ROCKY FLATS SITE

REGULATORY CONTACT RECORD 2014-09

Purpose: Soil Disturbance Review Plan (SDRP) Update for Regrading the East Perimeter Channel (EPC) at the Original Landfill (OLF)

Contact Record Approval Date: October 6, 2014

Figure 1. OLF Soil Disturbance, Filling, and Grading Location

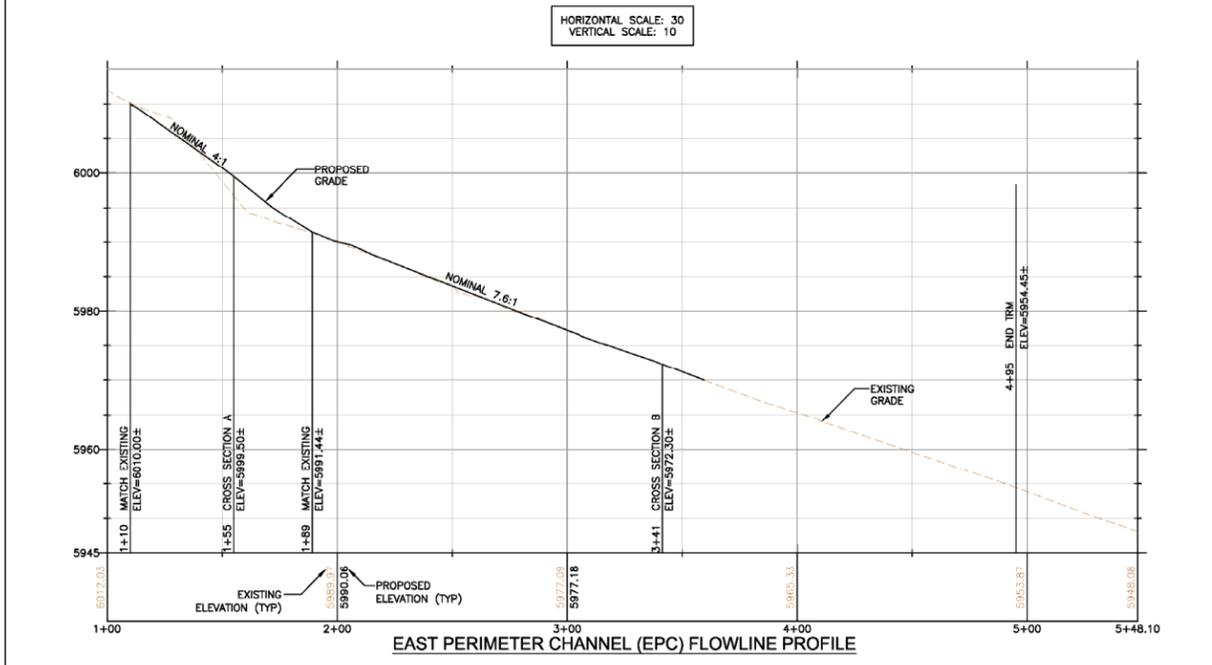
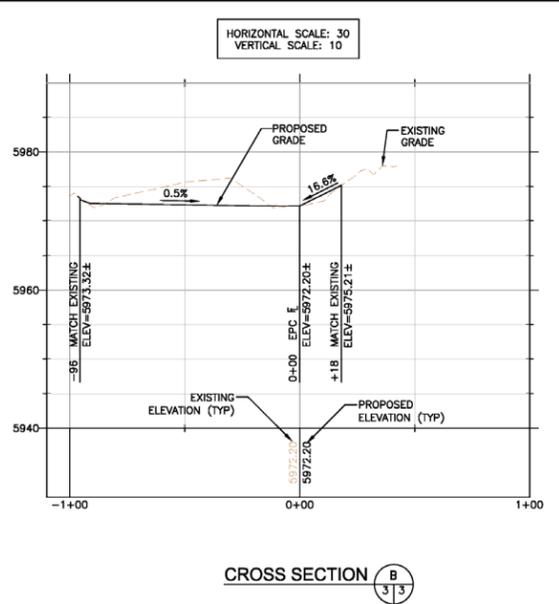
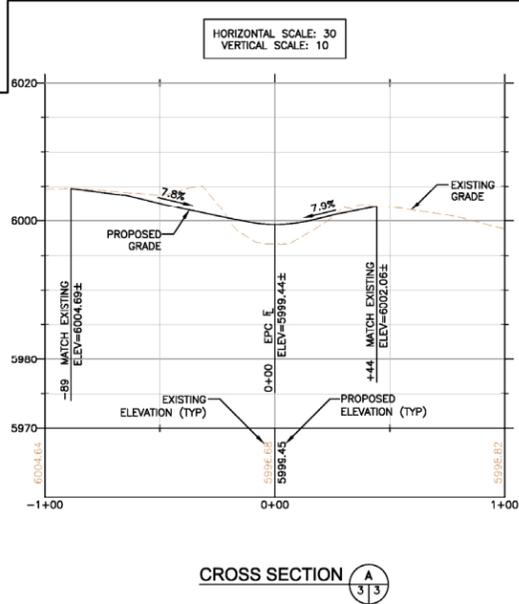
Discussion: DOE, CDPHE, and EPA met on August 5, 2014, to review the proposed update to the grading plan. The primary updates to the December 2013 grading plan are to cut back the ends of berms 4, 5, and 6 and taper the sides of the channel back to a more gradual slope. Figure 1 shows the location and anticipated aerial extent of the soil disturbance. The construction boundary is similar to the previous (December 2013) design, but soil disturbance is more extensive. There is a smaller area around the berm 4 flow line inside the “limit of waste” that will have new turf reinforcement material installed for erosion control. In October 2013 a slotted drainage pipe bedded in ¾-inch crushed drain rock was installed in the eastern end of diversion berm 4 as part of the initial response to the localized distress (see CR 2013-02), and this will be left in place. Another 4-inch slotted drainage pipe bedded in crushed drain rock will be installed between berm 5 and 6 to drain water from Seep #2/3 into the EPC. The excess soil will be distributed inside the COU as shown in Figure 2. No intrusive work will be performed within the waste footprint boundary.

Resolution: CDPHE has review information regarding the proposed soil disturbance and excavation and, after consulting with EPA, has approved the proposed activity and the proposed grading plan. CDPHE has determined that the proposed activity will not compromise or impair

Contact Record 2014-09 Figure 1 shows the location and the lateral and vertical extent of the excavation and soil disturbance. The slopes of the western side of the EPC between berms 5 and 6 will not be restored to the existing grade, therefore reducing or removing the 2-foot soil cover; however, this area is outside the “limit of waste.” The soil disturbance, regrading, and drainage feature installation work will not change the 2-foot-thick soil cover within the limits of the buried wastes. The material (Rocky Flats Alluvium) excavated from the cut areas will be used as fill in the fill areas. The excess soil will be distributed at designated locations in the COU as shown in Contact Record 2014-09 Figure 2.
